**Subject: SP24-128 • Parent Project SUB23-016 • Black Rock Coffee • S. Parker Rd. & Stroh Rd.
Review Comments 01: Response Letter**

The following are responses to comments received from Case Planner, Julia Duncan, with the Town of Parker Planning Department, dated February 4th, 2025, regarding the submittal of a land use application with the Town of Parker.

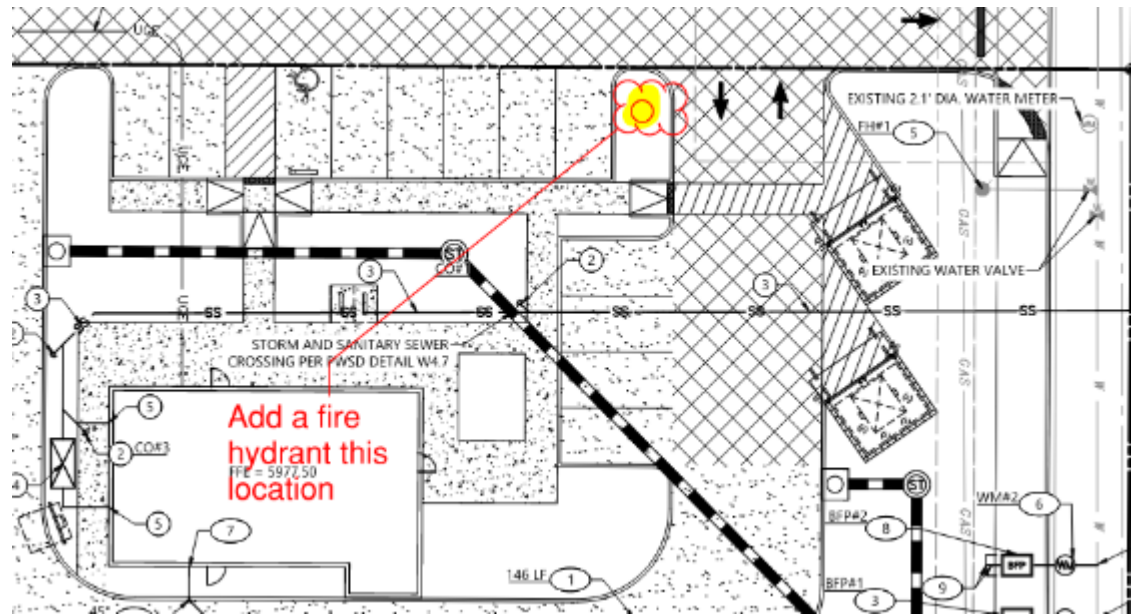
1. The applicant shall provide NO PARKING – FIRE LANE signage for any portion of the access where the 24-foot clear width requirement cannot be met.

Note - The Town of Parker requires that fire apparatus access roads meet the clear-width and weight-bearing standards of the jurisdiction in which the project is located. Roadways shall be designed to support the imposed weight of fire apparatus, 30-ton, two axle and 40-ton, three axle vehicles. An unimpeded clear width of 24-feet shall be always maintained. As such, any location where parked vehicles would obstruct this clear width requirement will require “NO PARKING – FIRE LANE” signage. *This signage shall be red on white. Design criteria have been provided at the end of this document; ensure compliance when resubmitting.*

➤ This 24’ width requirement is always maintained, with drive aisles (excluding drive thru lanes) ranging from 24’ to 31’. As a result, no “NO PARKING – FIRE LANE” signage is required.

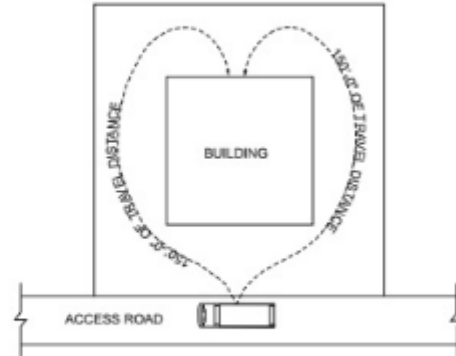
- The applicant shall be aware that the access road hydrant distribution was not planned to address the suppression needs for all commercial properties within this subdivision; this site requires the addition of one hydrant (to be located at the s/e corner island of the building... as required per NFPA 24 Section 7.2.3. The hydrant shall be located within 40 feet of the building to be served. A fire hydrant shall be provided and located in the northeast island (see below) and address this issue when resubmitting.

➤ This fire hydrant and associated lines/valves have been added to both the original sheet set and the PWSD sheet set.

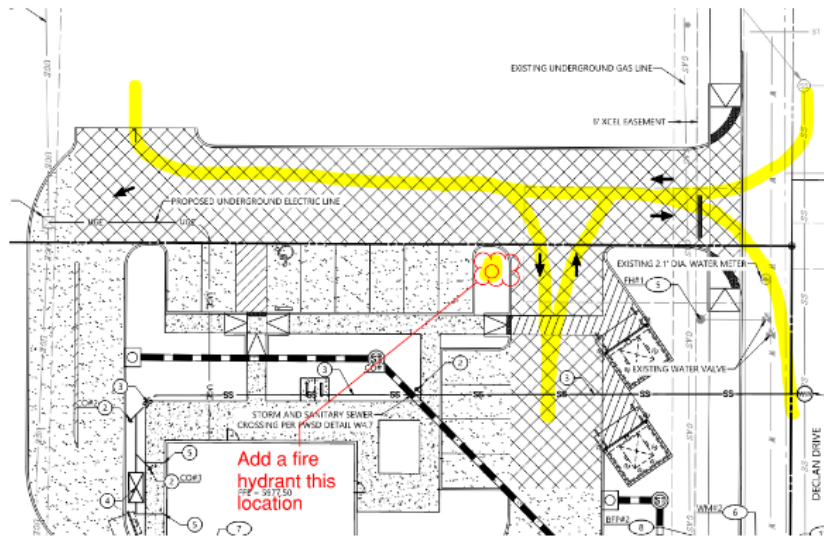
- a. ➤ This Fire Hose Proximity Exhibit has been included with this resubmittal.
6. In the event that the building needs to be sprinklered, the riser room shall be located in an accessible location (northeast corner of the building) and shall meet the following requirements:

The riser room shall be sized to accommodate the following:

- a. *The underground fire line is not allowed to have domestic tapped off of it*
- b. *The sprinkler riser is allowed to enter no further than 24-inches into the building (and any less than 12-inches into the building).*

- c. *A three-foot clearance shall be provided in front of the riser (with 18" of clearance on either side of the riser).*
- d. *The fire alarm control panel (FACP) is required to be located on an interior wall.*

- e. *A three-foot clearance is required in front of the FACP.*
- f. *Exterior access is required to be provided into the riser room; this access shall be approved.*

- g. *Access into the building shall be provided through the riser room or immediately adjacent to the riser room.*
- h. *While domestic water can be located in the riser room, the domestic cannot be located in any way that conflicts with the access requirements for both the FACP and the sprinkler riser.*

- i. *A sidewalk is required to the riser room and a 5 x 5 pad is required in front of the FDC.*

The applicant shall **provide a floor plan of how the riser room is to be laid** out to avoid conflicts with the site plan once the building review submittal has been made; this project will not be approved without this requirement having been met and approved.

- We should not need a riser room as the building does not need to be sprinkled at this time.

Sheet Set Redlines:

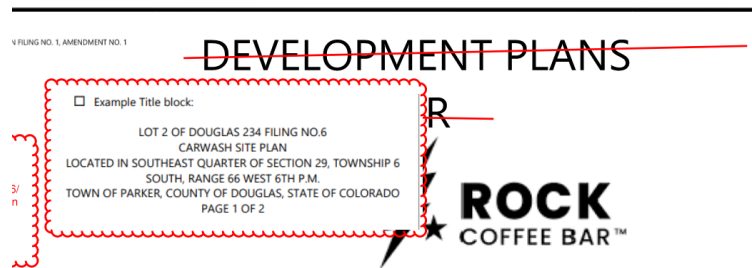
3. This detail is for mainlines.
 - This detail has been deleted from the sheet set.
4. Copper service line.
 - This water service note has been edited to reflect this change.

5. Note needed as type K copper is bendable.
 - This note has been removed and replaced by another to minimize renumbering. (note #11 became note #4).
6. Sewer service cannot tie into an in-line manhole.

- This manhole has been removed, to tie into existing sanitary sewer line.
7. Add a sampling manhole.
 - Sampling manhole has been added and labeled on all relevant sheets.

Site Plan Sheet (C2.00)

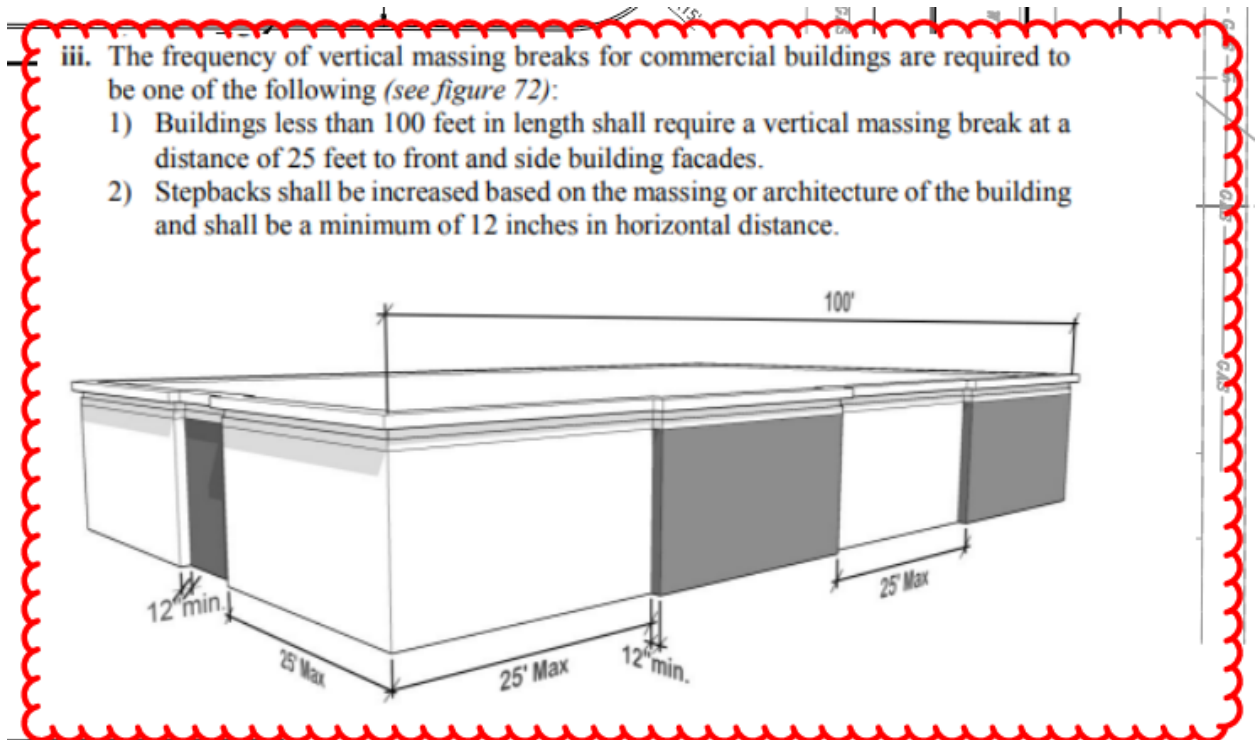
1. Include scale
 - A 1" = 20' scale was provided in the bottom right of the sheet.
2. Dimension sidewalk. Dimension setbacks to all building lines from property lines.

6. Dumpsters should not be the first thing you see when entering the site. Push further south and orient 90-degree angle so not a visual when pulling in.

- Sidewalk was dimensioned at 5'. A 40' and 65' building setback were also included on the sheet and labeled accordingly.
3. Dimension building length and widths to show plane break consistency.

- Per our conversation with Julia on Feb 24th, 2025 the dumpsters have been condensed into one large enclosure and rotated to orient 90° to the road.
7. Revise site summary table to reflect Mixed-Use Community – break into columns showing required and proposed.
